Form 3160-5
(June 2015)UNITED STATES
DEPARTMENT OF THE INTERIOR
BUREAU OF LAND MANAGEMENTFORM APPROVED
OMB No. 1004-0137
Expires: January 31, 2018**SUNDRY NOTICES AND REPORTS ON WELLS**
Do not use this form for proposals to drill or to re-enter an abandoned well. Use Form 3160-3 (APD) for such proposals.

Proposed
Cato San Andreas Unit # 133
API # 3000520125

Notice of Intent to PA- Procedure

**Cato San Andres Unit 133
30-005-20125
Oxy USA Incorporated
October 11, 2022
Conditions of Approval**

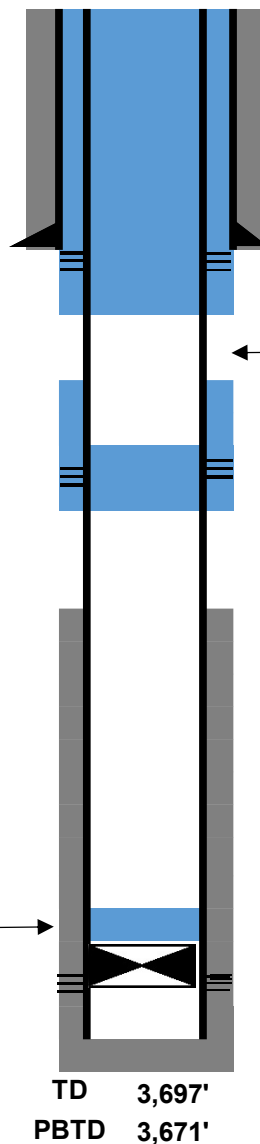
Perf and circulate CI C cement to surface. Verify cement to surface.

Perf and squeeze. 100 sx on backside, 25 sx inside casing for Yates plug.

Set CIBP and dump bail 5 sx CI C cement. WOC and tag.

1. SET CIBP @ 3500ft. DUMP 5 SX CLASS C CMT. WOC AND TAG
2. P&S @ 1740ft. SQUEEZE 100 SXS INTO CSG SPOT 25 SXS IN TBG. WOC AND TAG
3. P&S SURFACE PLUG@ 340ft. SQUEEZE 145 SXS CSG. CONFIRM CMT TO SURFACE

- 1. Operator shall place CIBP at 3,500' (50'-100' above top most perf) and place a minimum of 25 sx of Class C cement on top. WOC and TAG.**
- 2. Operator shall perf at 1,740' and squeeze 100sx class C cement as proposed. Must tag a minimum of 1,170' to seal the Yates and Salt Formations. WOC and TAG.**
- 3. Operator shall perf at 340' and squeeze class c cement to surface to seal the 8-5/8" casing shoe.**
- 4. Dry hole marker must be below ground.**
- 5. Surface reclamation will need to be completed once the well bore has been plugged. Please contact rflores@blm.gov for additional information.**
- 6. See Attached for general plugging stipulations.**
